## Introducing the Improved 42-CB2 Controller Interface Box

We are thrilled to announce the consolidation of our 42-CB2 and 42-CB4 Controller Interface Boxes into a single, enhanced 42-CB2 model. This update simplifies our product line, reduces costs, and provides greater versatility to meet your operational needs.

## Improved 42-CB2

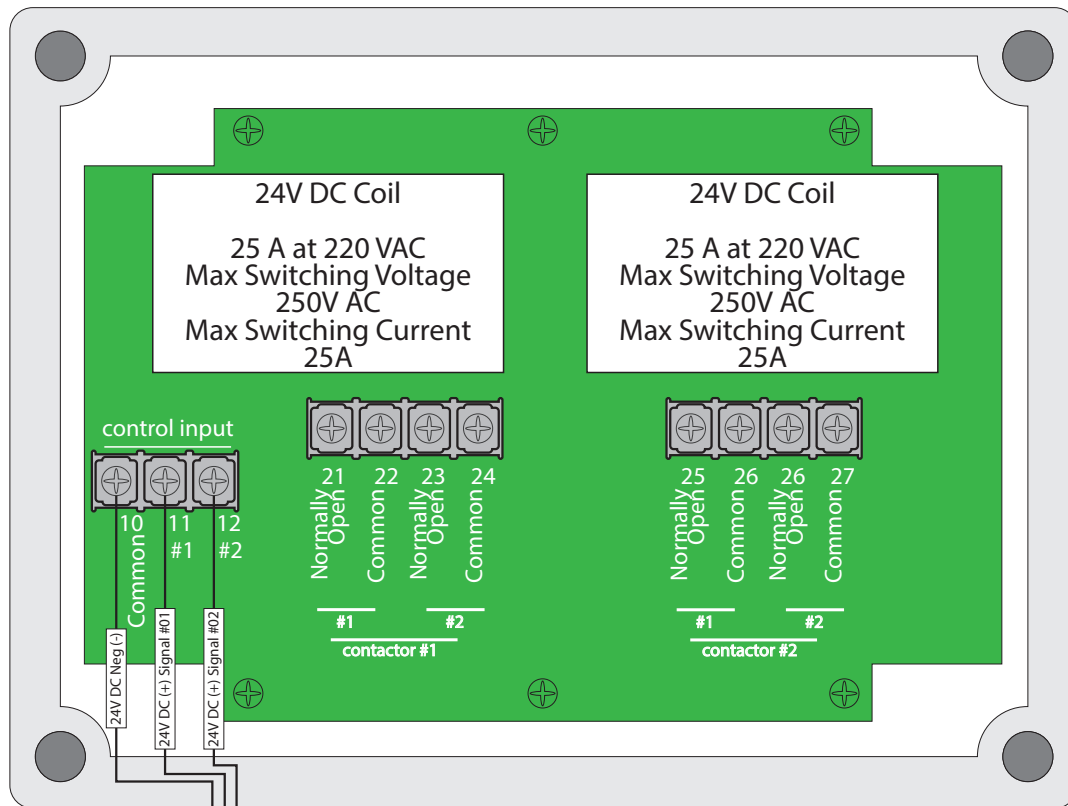
The updated 42-CB2 Controller Interface Box is equipped with **two double-pole, single-throw contactors**, offering enhanced performance and flexibility:

- **Versatile Voltage Support:** Operates up to four (4) 120-volt or two (2) 240-volt, 1 HP AC motors, accommodating both 110-volt and 220-volt assets.
- **High Capacity:** Each contactor supports up to 20 amps inductive load per pole, allowing parallel operation of assets for increased efficiency.
- **Flexible Control Options:** Run each contactor independently with separate setpoints or configure setpoints to operate in parallel for synchronized control.
- **Reliable Design:** Built with durable double-pole, single-throw contactors for consistent performance in demanding applications.

The improved 42-CB2 replaces both the 42-CB2 and 42-CB4 models, effective immediately. Our customer support team is ready to assist with any questions about compatibility, installation, or specifications.
